SNARE HYDRO SYSTEM

2006 Comprehensive Dam Safety Review

A Comprehensive Dam Safety Review (DSR) of the Snare Hydro System was performed by Klohn Crippen Berger Ltd. (KCBL) between July and December 2006. The DSR was performed in accordance with Section 2 of the Canadian Dam Association, Dam Safety Guidelines.

Figure 4-1: Snare Cascades – Labyrinth Spillway Rating Curve

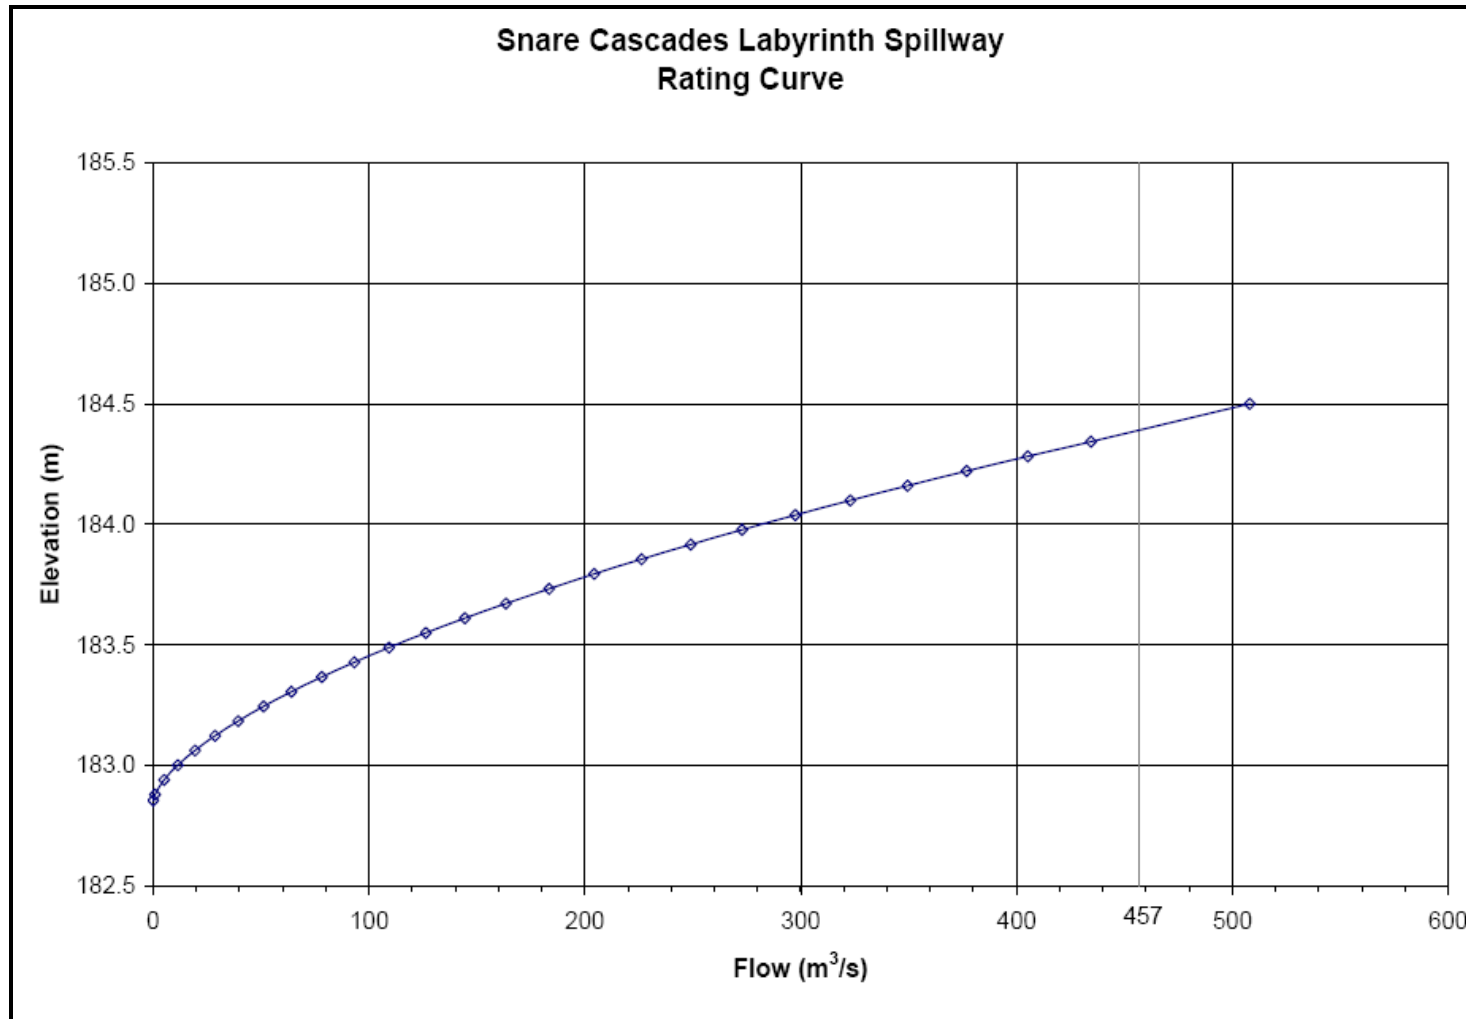
Figure 4-1 illustrates the spillway rating curve for Snare Cascades. It is evident that the Snare Cascades labyrinth spillway has the capacity to safely pass the 1 in 1000 year routed IDF of $457 \text{ m}^3/\text{s}$. The top of the concrete cut-off in the Approach Channel Dyke is EL. 184.5 m.

Figure 6-3: Snare Rapids Main Dam – Core Thermistor Readings (2000 to Present)

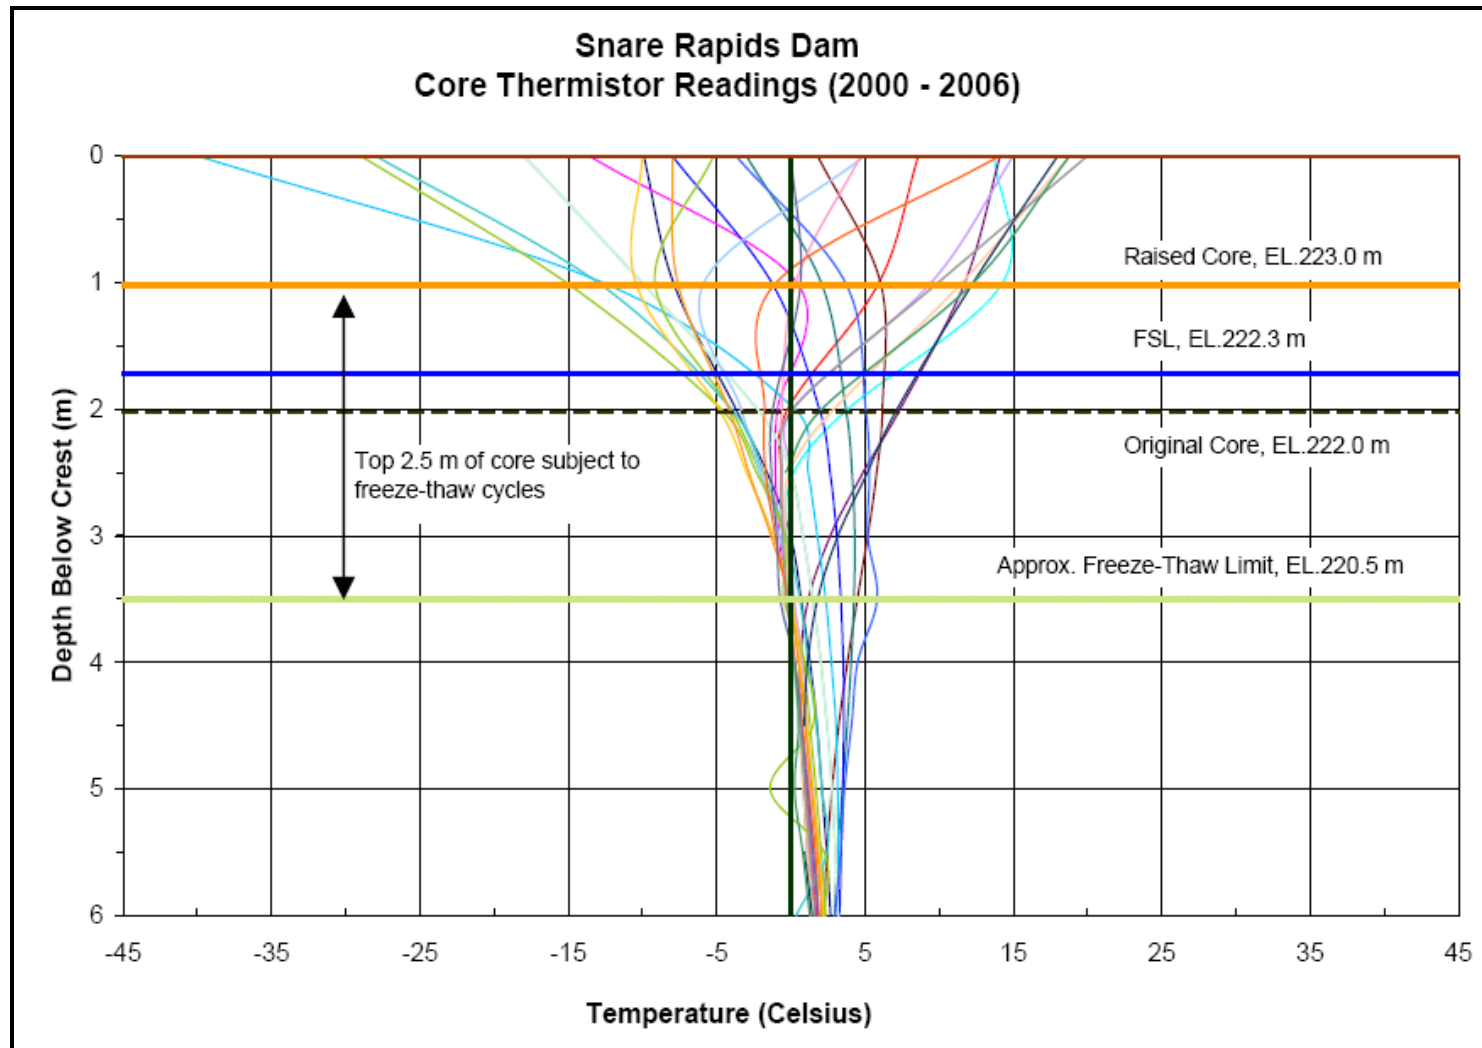
In 2000, a single multi-level thermistor was installed in the top 6 m of the main dam to record temperature fluctuations at 0.5 m intervals in the top of the dam and core. Figure 6-3 charts the data presented in Appendix IV. From Figure 6-3, frost penetration extends approximately 2 to 2.5 m (6.5 to 8 ft) into the upgraded core of the dam. However, laboratory testing and material assessments undertaken during the 2000 DSR concluded that the existing core material has low to negligible frost sensitivity due to its relatively high clay content (50 to 70% fines and 17% clay content) and consequent low permeability. Properties of the materials used to increase the height of the core were not available for review, but are assumed to have similar frost sensitivity properties. Although deterioration from freeze-thaw effects is unlikely based on the previous assessment, it is recommended that seasonal readings (4 per year) should be maintained as a minimum to confirm that no adverse conditions develop in the upper part of the dam and core which could potentially lead to deterioration. To this end it is noted that only 2 thermistor readings have been taken since June 2002.

Figure 6-4: Snare Rapids Main Dam – Stability (Normal Load Case, FS = 1.61)

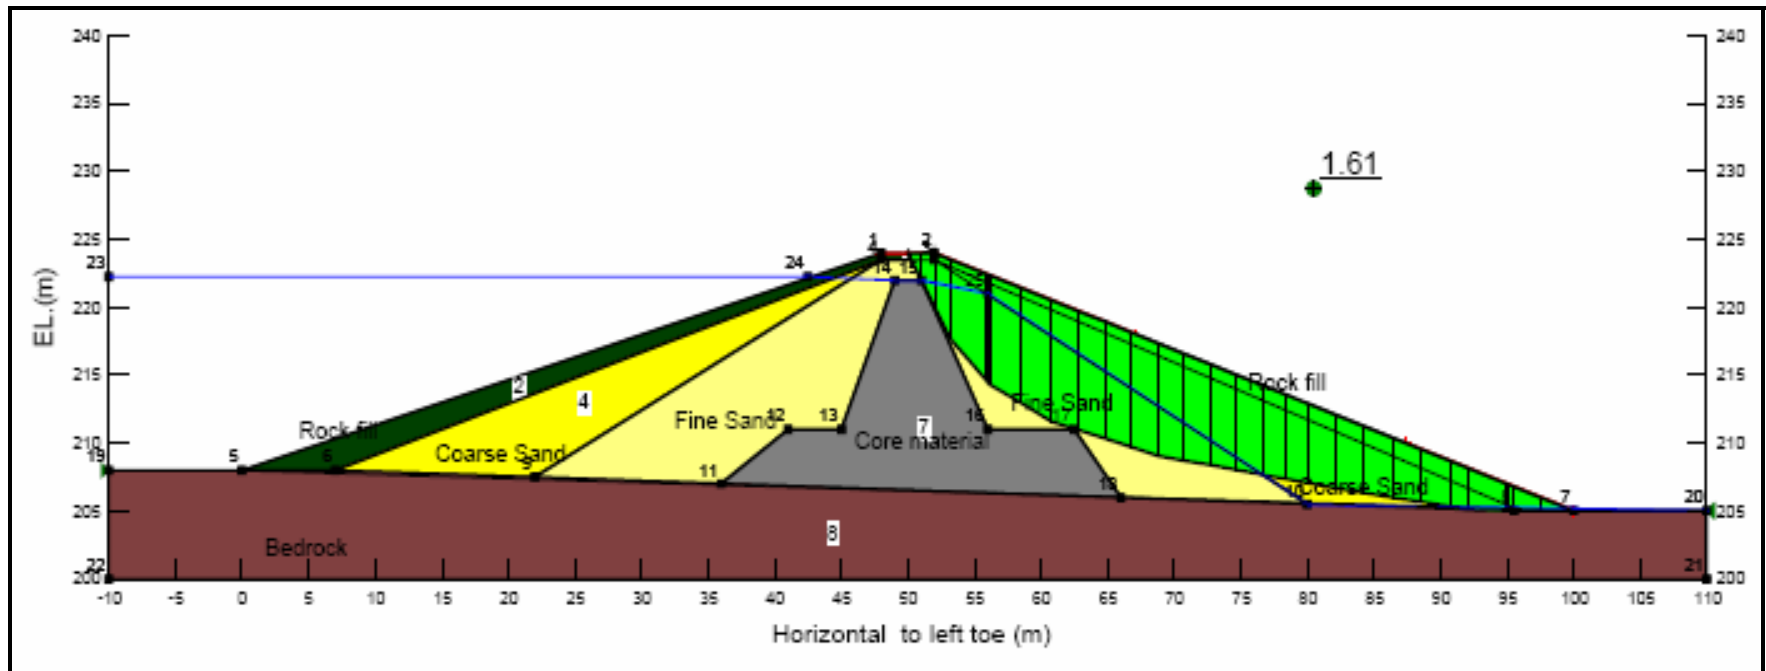
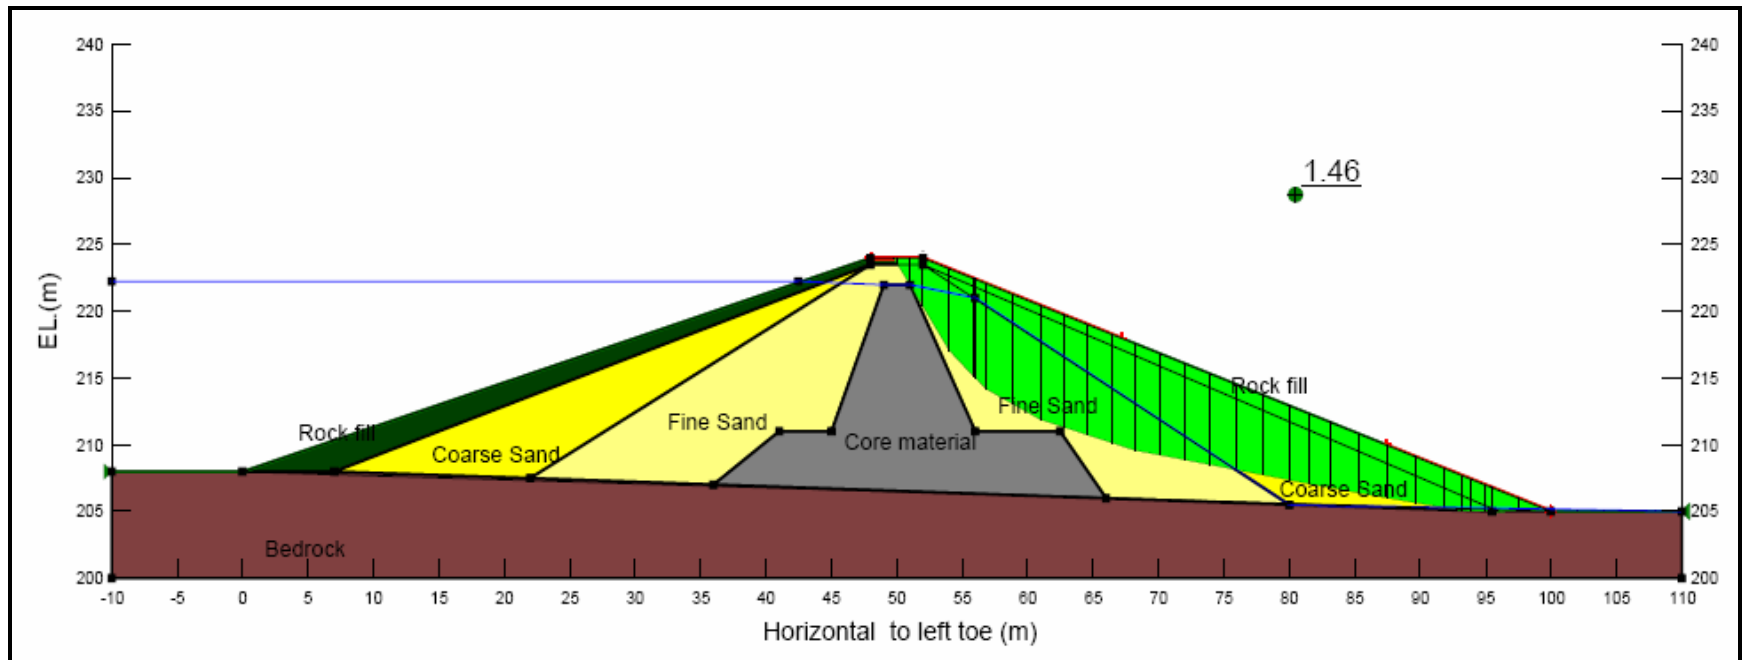
As illustrated on Figure 6-4 and Figure 6-5, the factors of safety for both the static and seismic load cases are considered to be satisfactory.

Figure 6-6: Snare Rapids Power Tunnel – Weir Flows

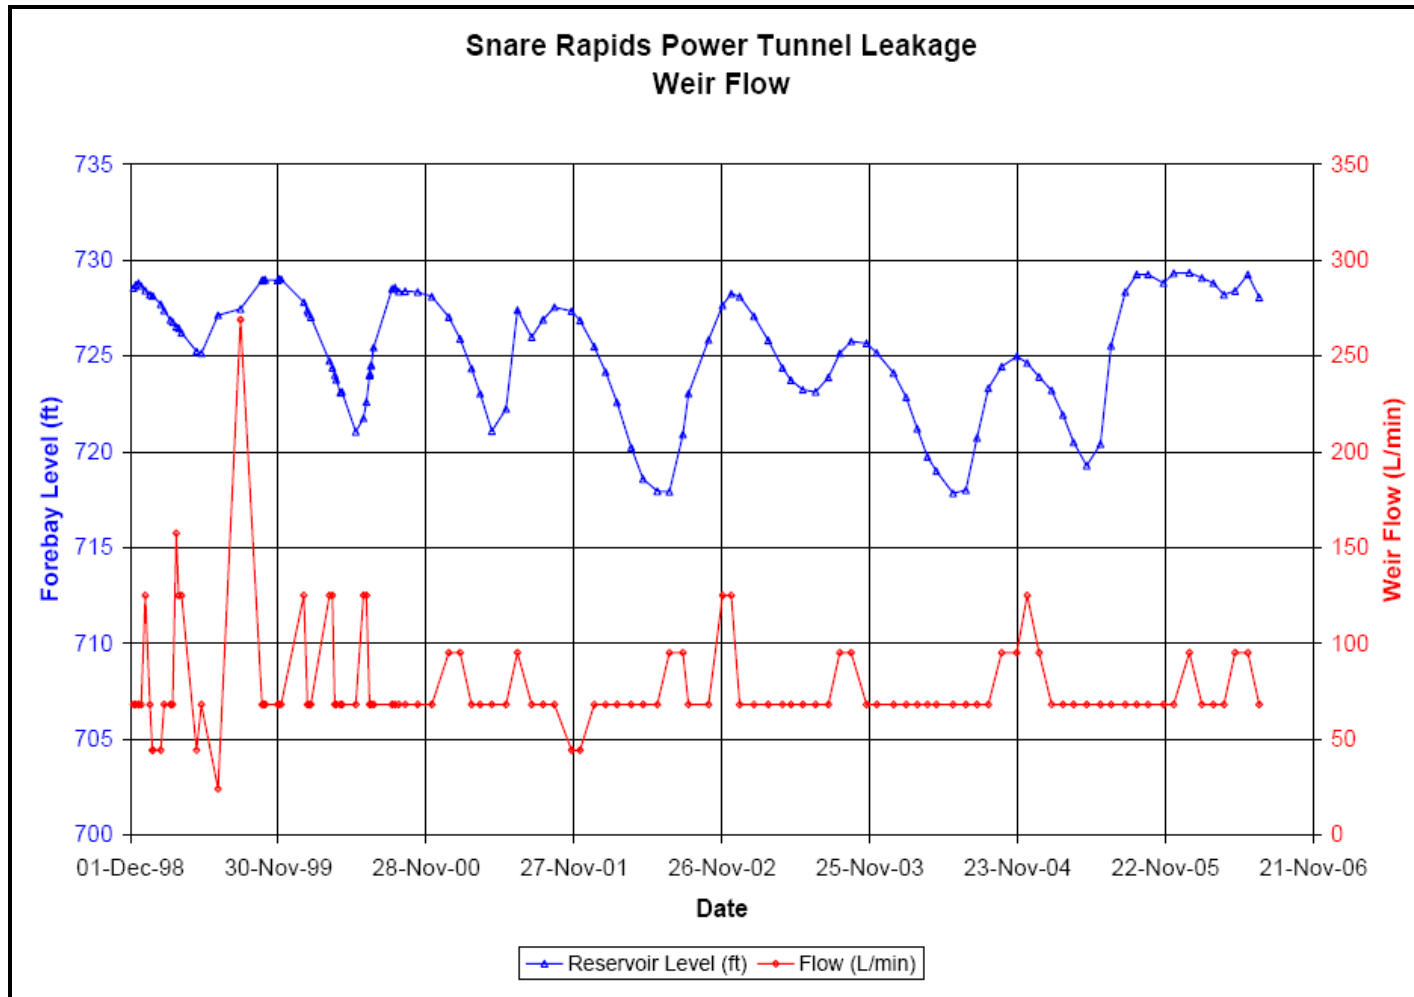
Figure 6-6 illustrates the reduction and stabilization in flow following the 1999 grouting program. Inflows generally vary with reservoir level and are typically in the order of 50 L/min to 70 L/min during lower reservoir levels, peaking between 100 and 125 L/min during high reservoir periods. The magnitudes of flows are fairly consistent with no increasing trends which would be indicative of foundation deterioration (piping) of the water bearing feature or decreasing trends which may indicate clogging of the drains along the upstream side of the powerhouse. Monitoring of seepage from the power tunnel should continue on the present schedule.

Figure 6-8: Saddle Dam 5B – Weir Flow Measurements

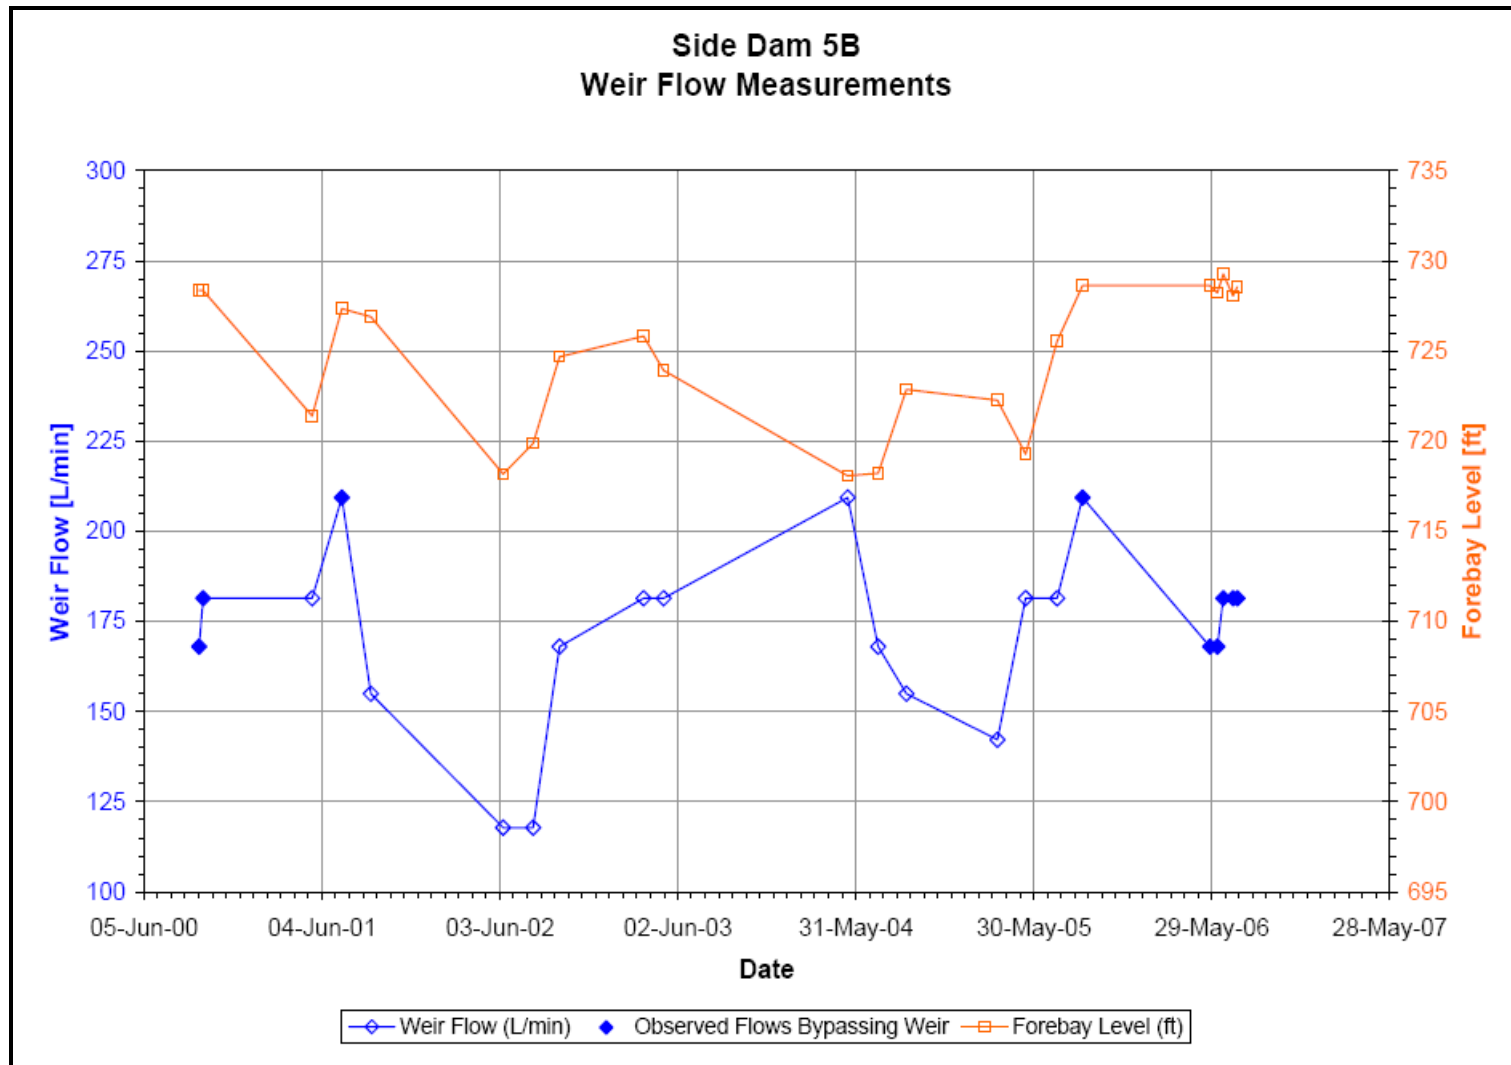
Also from Figure 6-8, there appears to be a general correlation of higher seepage with higher reservoir levels, however the precise trend is somewhat masked by the fact that the weir fails to collect all flows, notably during periods of higher leakage, where some flow bypass is witnessed along the left side of the structure (Photo 17). This makes it particularly difficult to determine whether the flows during times of higher seepage are actually trending upward, indicative of a deteriorating situation.

Figure 9-3: Snare Forks – 2005 Crest Survey: Dyke 2, 3 and Snare Forks Dam

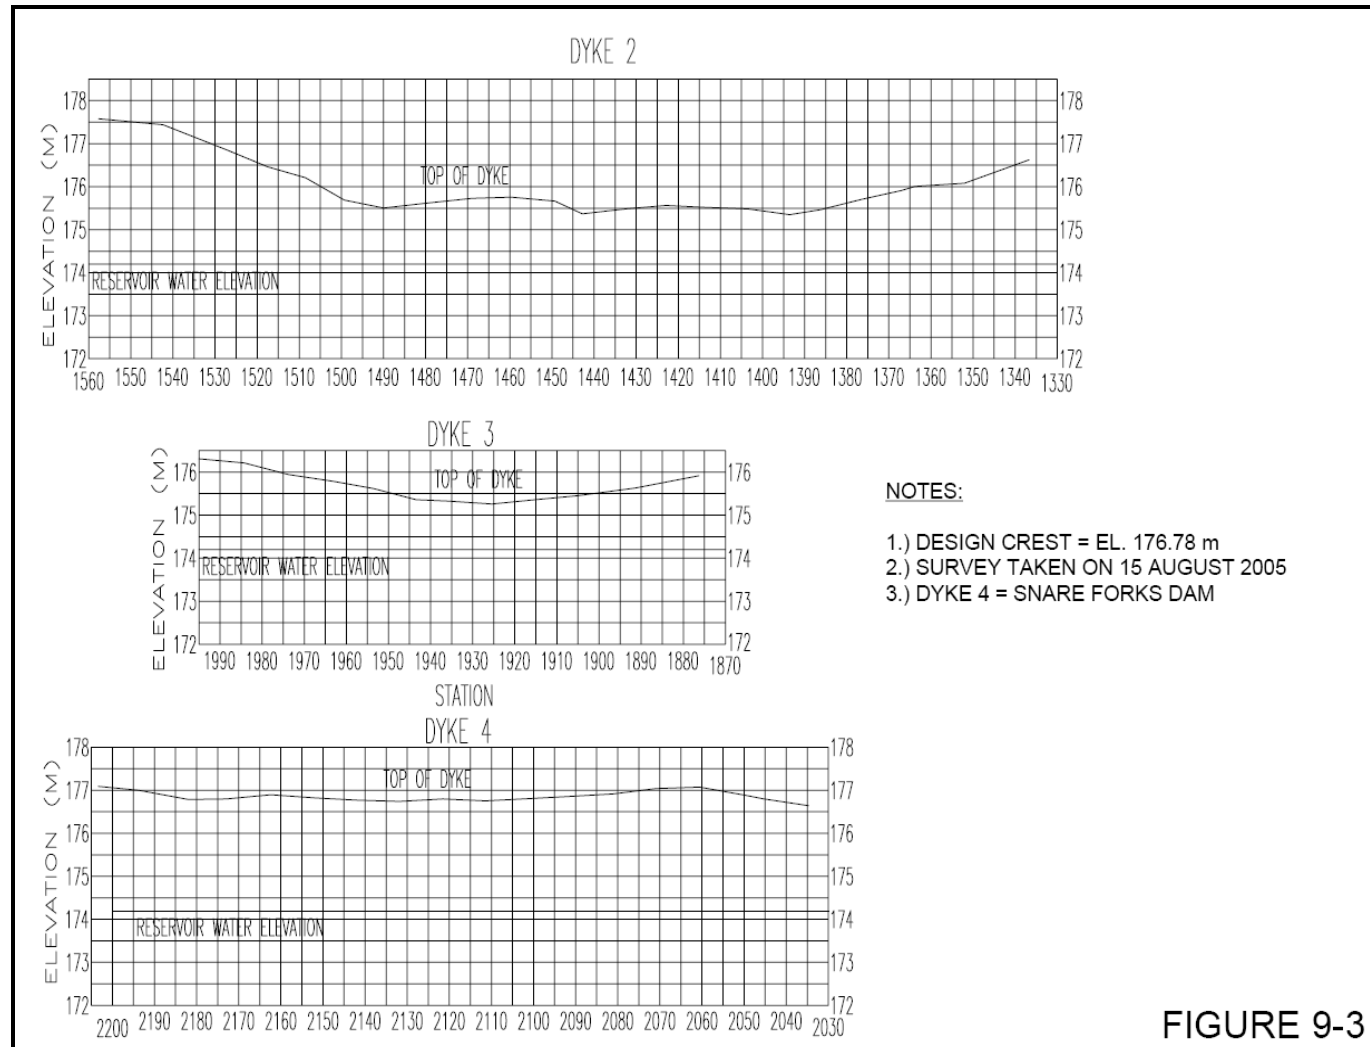
An August 2005 centreline survey (see Figure 9-3) shows the crest of Snare Forks dam varying from slightly above design grade (0.3 m) to very slightly below design grade (0.04 m).

- the crest of Freeboard Dyke 1 was 0.78 m (2.6 ft) to 2.10 m (6.9 ft) below design grade (see Figure 9-4);
- the crest of Freeboard Dyke 2 varied from 0.07 m (0.2 ft) above design grade to 1.43 m (4.7 ft) below design grade (see Figure 9-3); and
- the crest of Freeboard Dyke 3 was 0.84 m (2.8 ft) to 1.52 m (5.0 ft) below design grade (see Figure 9-3);

At the time of the current inspection, NTPC staff reported that the dyke had recently been topped up. The 2005 crest survey results (Figure 9-3) are therefore not representative of the conditions experienced during the site inspection.
